Service Advisory

CC-660

2500 SERIES

Subject: **Hood Brace Kit 759-04237.**

FIGURE 1

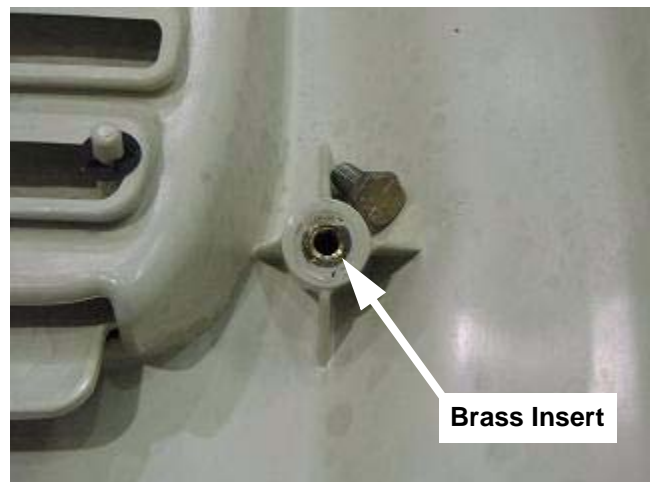
PURPOSE: Hood Brace Kit **759-04237** is to be used on hoods that already incorporate the use of the 710-1242 Hi-Lo Screws, See Figure 1 below. These four (4) screws are used to mount the hood to the hood pivot bracket. This Service Kit will enhance the strength and durability of the existing hood by using longer Hi-Lo screws and a center hood brace and hood brace plate.

Order and install the Hood Brace Kit **759-04237**. If hood is damaged and needs replacing see note below for proper Service Kit to order and install.

FIGURE 2

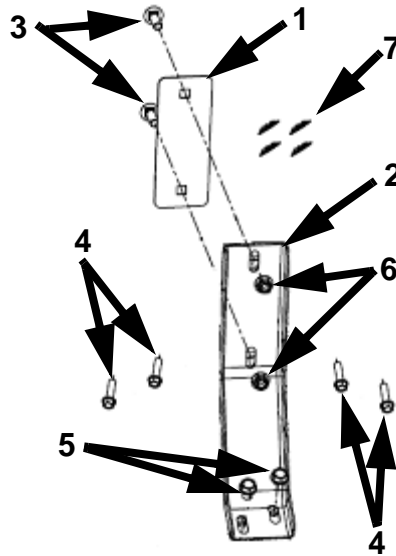
NOTE: *If the unit being repaired, still has the style of hood with the brass inserts, (see Figure 2 below) that use a 1/4-20 hex head bolt to mount the hood to the pivot bracket. Order and install one of the updated hood Service Kits listed below, (depending on serial number of the unit and requirement). These Service Kits will include the items contained in this Service Kit (759-04237).*

759-04136B is used for 2500 Series Tractors built Prior to January 13, 2006.

759-04137B is used for 2500 Series Tractors built January 13, 2006 through October 31, 2006.

759-04209A is used for 2500 Series Tractors built November 1, 2006 and After.
